Technical Service Information

THM 440-T4 2ND GEAR STARTS

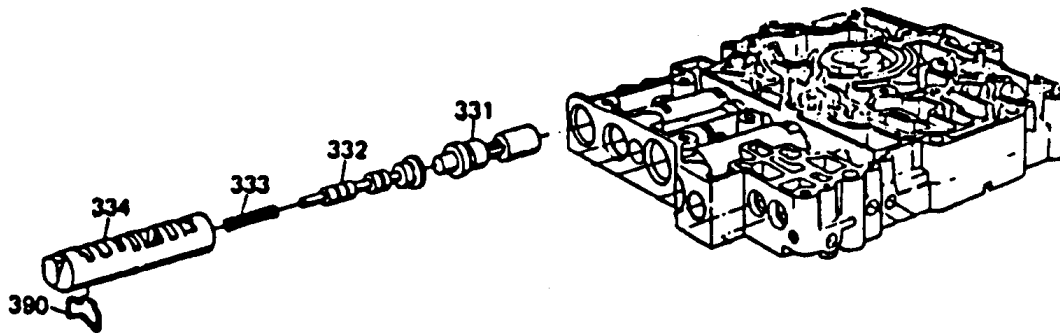
CORRECTION: Modify the original 1-2 shift valve as shown in Figure 2. This is a very simple machining operation on a lathe. The factory has upgraded the 1-2 shift valve with a "Boss" cast on the end of the valve (See Figure 2).

Figure 1

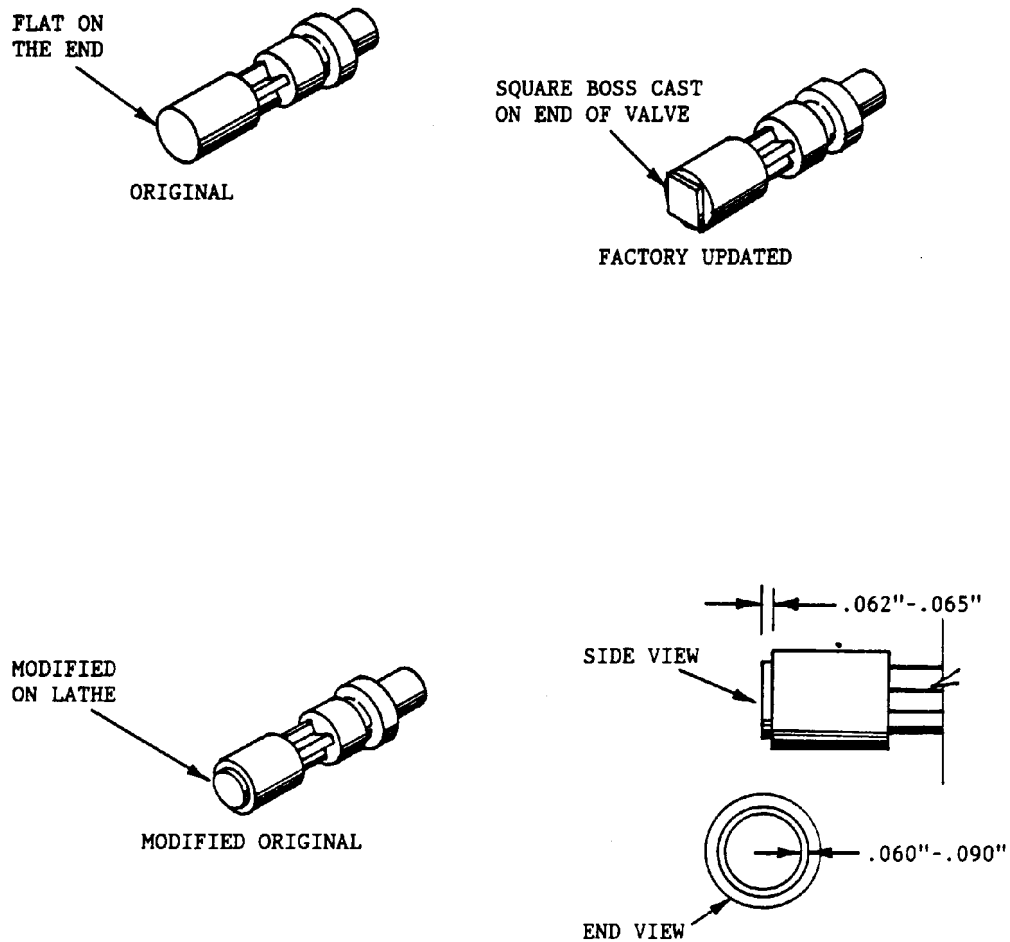
COMPLAINT: Vehicle starts in 2nd gear after a upshift sequence, but will usually take manual low.

CAUSE: The cause may be the 1-2 shift valve sticking in the upshifted position (See Figure 1). The 1-2 shift valve is aluminum and might have a tendency to "Mushroom", caused by hitting the valve body casting in the bottom of the bore.
